Origination Form
Proposed Revisions to a Standard Plans Index

Originator:	Holley, Tim	Index Number:	425-015
Date:	7/1/2026	Sheet Number(s):	1-2
E-mail:	Tim.Holley@dot.state.fl.us	Index Title:	Manhole Tops

The manhole top and cover information from 425-001 is being moved to a new Index: 425-015.

NEW INDEX 425-015

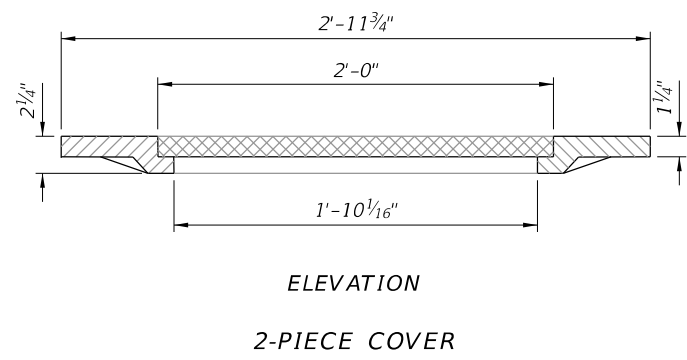
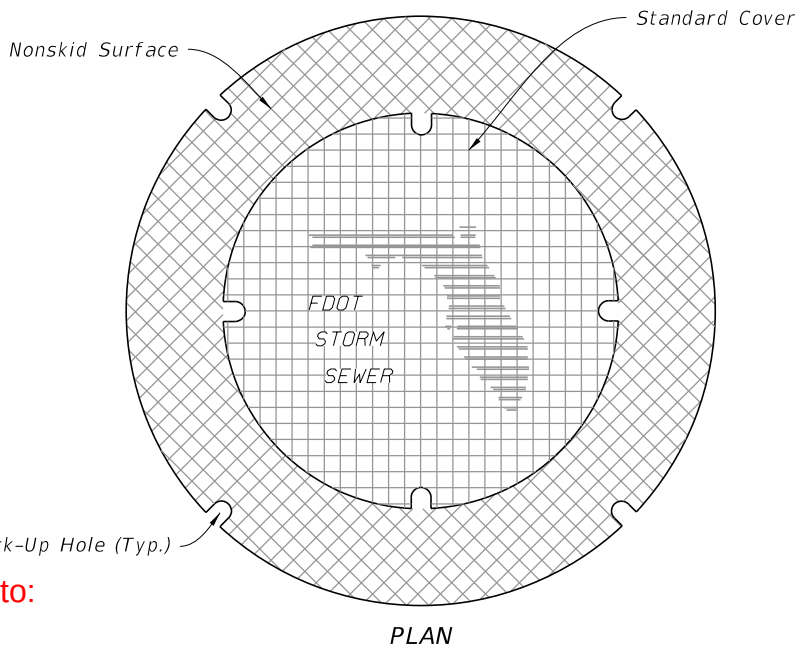
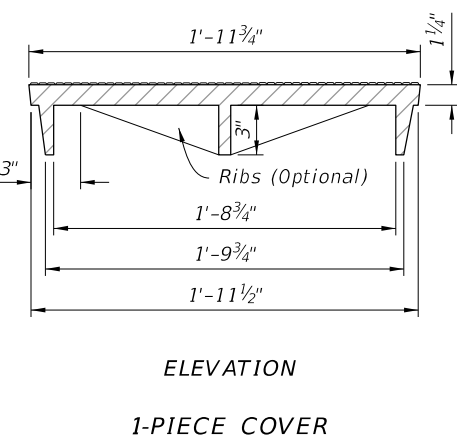
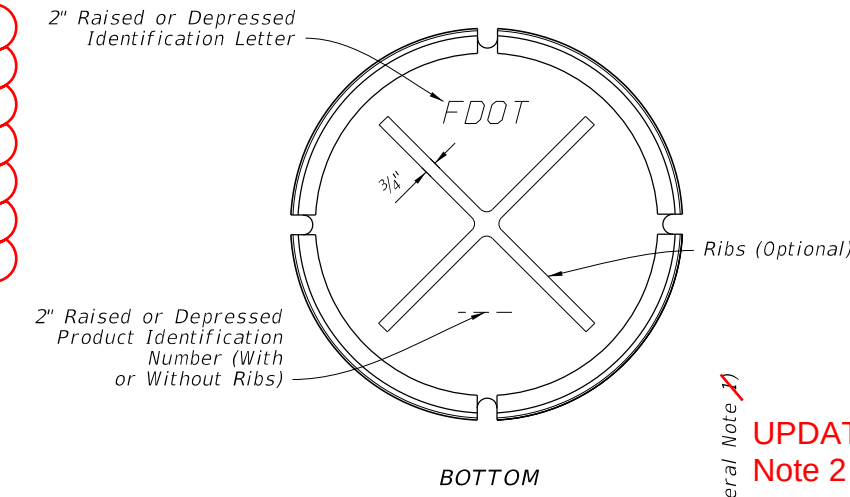
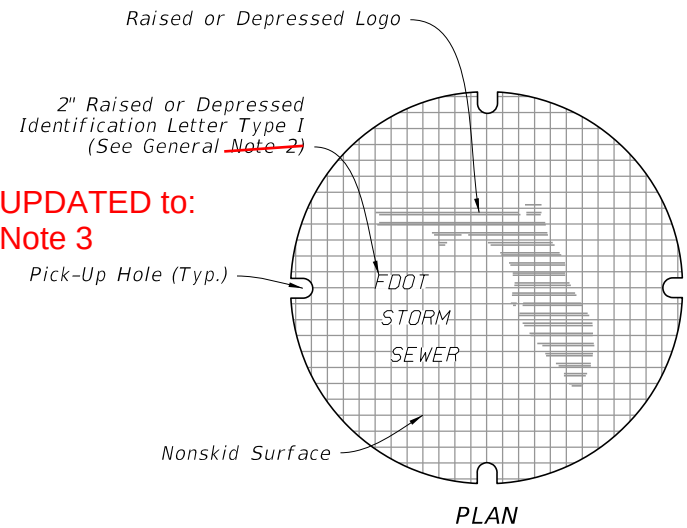
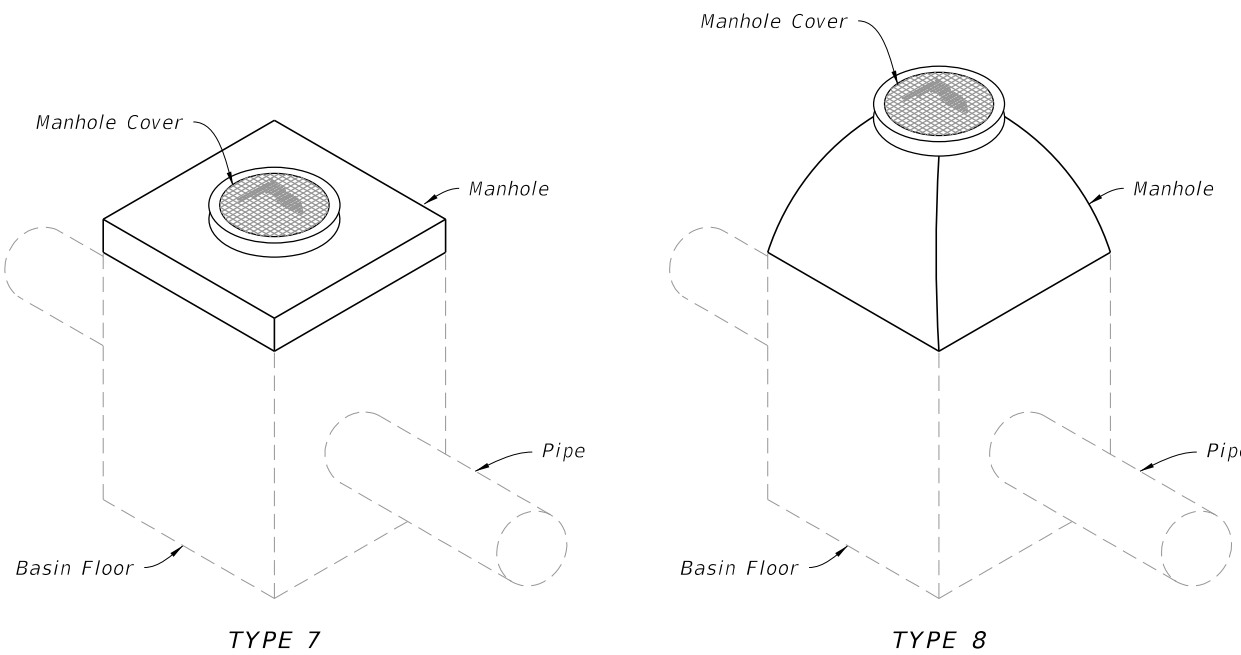
ADDED NEW NOTE 1:
"1. Work this Index with Index 425-001 and Index 425-010."
GENERAL NOTES: Renumbered current Notes.

2. ~~1.~~ Use a 1-piece cover, unless the 2-piece cover is called for in the Plans, except at inlets and manholes with sump bottoms. Use the 2-piece cover when the sump depth exceeds 2', unless otherwise noted.

3. ~~2.~~ Include "Adjustable" on the cover for Type I manhole adjustable frames.
3. For square or rectangular precast drainage structures, use either deformed or smooth WWR meeting the requirements of Specification 931. WWR must be continuous around the box and lapped in accordance with Option 1 or 3 as shown in the Wall Reinforcing Splice Details.

DELETED NOTES: 3 through 7

DELETED SHEETS NOTES: 3 through 8

UPDATED to:
Note 2

CHNAGED SHEET NO. to 2

CHANGED to: 425-015
